AMERICA'S CUP 36

Interpretation 032

AC75 Class Rule Version 1.7 issued 4th November 2019

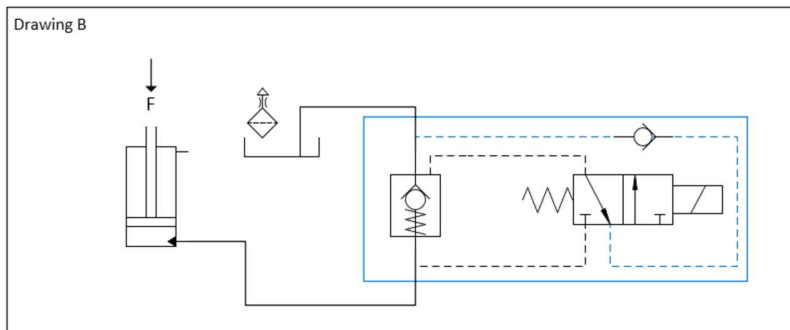
1. Drawing A shows a single acting cylinder that can be discharged to a vented tank via a valve. The cylinder can be refilled from the tank when the **external force** is reversed. The specification of the valve is shown in the Appendix. Note that valves of this type take the pilot pressure from port 2.
 - a. Is the valve as drawn controlled by an **ECC**?
 - b. Is the valve as drawn actuated by an **ECC**?
 - c. Is this arrangement legal according to the **AC Class Rule**? If Yes, please indicate which part of rule 22.5 permits this valve. If No, please indicate which part/parts of the class rule is/are infringed by the arrangement.

1.
 - a. Not evident from the supplied information.
 - b. Not evident from the supplied information.
 - c. The question does not specify whether this valve is connected to an **ECC** or if the **ECC** controls the valve. For the purposes of answering 1.c it is assumed that the solenoid actuator is electrically connected to and receives electrical signals to drive it from an **ECC**. With that assumption, yes. It is permitted by rule 22.5(c), with the stated assumptions in the supplied specification and in Drawing A, that it is a two port device, and with the statement in the question that the pilot pressure is taken internally (from port 2).

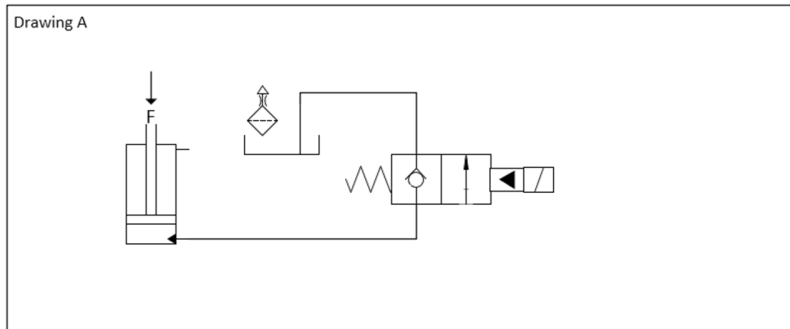
2. The valve in drawing B is a Pilot operated check valve controlled by a valve actuated by an **ECC**.
 - a. Is the Pilot operated check valve as drawn controlled by an **ECC**?
 - b. Is the Pilot operated check valve as drawn actuated by an **ECC**?
 - c. Does this arrangement comply with the **AC75 Class Rule**? If Yes, please indicate which part of rule 22.5 permits this valve. If No, please indicate which part/parts of the **AC 75 Class Rule** is/are infringed by the arrangement.

3. Consider drawing B again. The devices shown in the blue box are supplied as a single valve, together with a datasheet describing it as a "Solenoid Valve, Normally Closed, Pilot operated, Poppet Type (2/2)". Does this arrangement comply with the **AC75 Class Rule**? If Yes, please indicate which part of rule 22.5 permits this valve. If No, please indicate which part/parts of the **AC75 Class Rule** is/are infringed by the arrangement.

2.
 - a. No.
 - b. No.
 - c. The arrangement in Drawing B, containing three valves, a low-pressure accumulator and an actuator chamber, as drawn, is rule compliant. The question additionally asks which part of rule 22.5 permits this valve. It isn't clear which of the three valves the question refers to. The pilot operated check valve shown is permitted by rule 22.5(e) as it is subject to the pressure of no more than one actuator chamber.

3. Question 3 contains inconsistent information so can only be answered in part and by stating assumptions. Question 1 and Question 3 both assert that the attached datasheet describes the valve in Drawing A, and also describes the contents of the blue box in Drawing B. Please supply more detail from the manufacturer to clarify the inconsistencies. Question 1 notes that, "valves of this type take the pilot pressure from port 2." The circuit in the blue box of Diagram B shows the pilot operated check valve as taking its pilot pressure from either port 1 or port 2 depending on the position of the solenoid. It isn't clear whether the valve referred to in question 3 is the same as the valve described in question 1. Question 3 asserts that the circuit within the blue box, comprising three valves, is supplied as one valve. Please provide a datasheet with sufficient detail to confirm that the devices shown in the blue box are supplied as a single valve. Setting aside whether the contents of the blue box are provided as a single valve with a corresponding datasheet, question 3 also asks whether "the arrangement complies with the **AC75 Class Rule**." The arrangement in Drawing B containing three valves, a low-pressure accumulator and an actuator chamber, as drawn, is rule-compliant. The question additionally asks which part of rule 22.5 permits this valve. It isn't clear which of the three valves in the blue box the question refers to. The pilot operated check valve shown is permitted by rule 22.5(e) as it is subject to the pressure of no more than one actuator chamber.
